# Groundwater Transfer Review Summary Form

Transfer/PA # T- 14701

Application: T-14701

Applicant Name: County of Clackamas

**Cross-section showing “top of basalt” in area wells** (note that information from CLAC 18421 and CLAC 20274 were used by USGS for CRBG mapping; also, “Prop 707” corresponds to proposed APOA “Well 6” and is assumed to be representative of the other two proposed APOA wells).

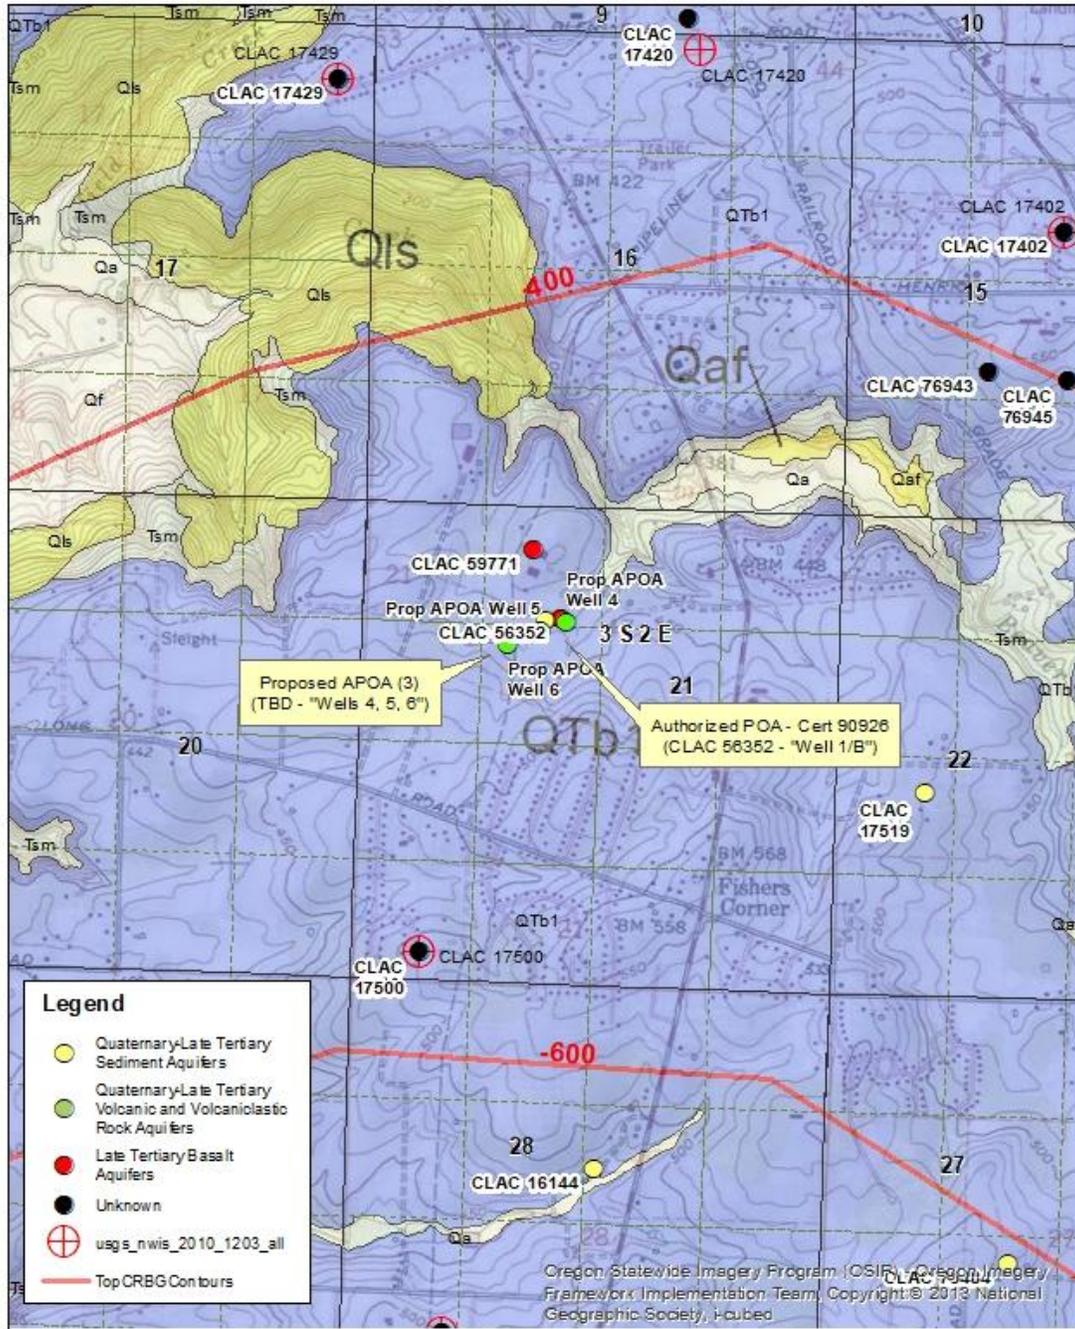
However, despite the “claystone” and “sandstone” designations on the CLAC 56352 log, it is highly likely that these rock types are instead basalt of the Columbia River Basalt Group (CRBG) aquifer system. This conclusion is based on the following factors: (1) the log for CLAC 59771, which is ~800 ft north-northwest of CLAC 56352 and at approximately the same ground surface elevation, shows basalt beginning at a depth of 960 ft bls (~elevation -525 ft msl); at and below this same depth, CLAC 36352 instead indicates “gray claystone” (and “gray sandstone” just above); (2) interpolation of the top of basalt contours from USGS geologic maps of the area (Wells and others, 2020) confirms the local presence of basalt as recorded in nearby CLAC 59771, with similar expectations at the nearby CLAC 56352 location (see attached location map and cross-section); (3) OWRD previously designated a CRBG aquifer source for CLAC 56352 (see 2017 GWIS entry by K. Wozniak); and (4) the set of water-level decline conditions contained in certificate 90926 are those typically assigned by OWRD for wells completed in the CRBG aquifer system.

It thus appears that authorized POA CLAC 56352 obtains groundwater from both sedimentary deposits corresponding to the Troutdale Formation and/or water-bearing portions of the Sandy River Mudstone **and** from the underlying CRBG aquifer system. Insufficient lithologic detail on the CLAC 56352 well log precludes being able to clearly distinguish between sedimentary rocks and underlying CRBG; however, the contact can be estimated by projecting the sediment/CRBG contact from CLAC 59771 at approximately elevation -525 ft msl (see attached cross-section; note that “Prop 707” corresponds to proposed APOA “Well 6”, and is intended to be representative of the other two proposed APOA wells) (Conlon and others, 2005; Swanson and others, 1993; Wells and others, 2020).

**Despite apparent commingling of aquifer types in authorized POA CLAC 56352, wells drilled as APOA under this transfer will be limited to only a single source (i.e., sedimentary or CRBG aquifer system).** Currently-planned construction details for the three proposed APOA (“Wells 4, 5, 6”) show total depths of approximately 1200 feet, cased and sealed between 0-700 feet. However:

**(1) If the applicant chooses a sedimentary aquifer source, the total depths are to be limited to approximately 960 feet, which corresponds to approximately elevation -525 ft msl at each of the three proposed APOA locations.**

**(2) Conversely, if a CRBG aquifer source is selected, then the cased and sealed portion of the APOA wells is to be extended to approximately 960 feet, or elevation -525 ft msl (actual depths will vary depending on borehole-specific conditions).**
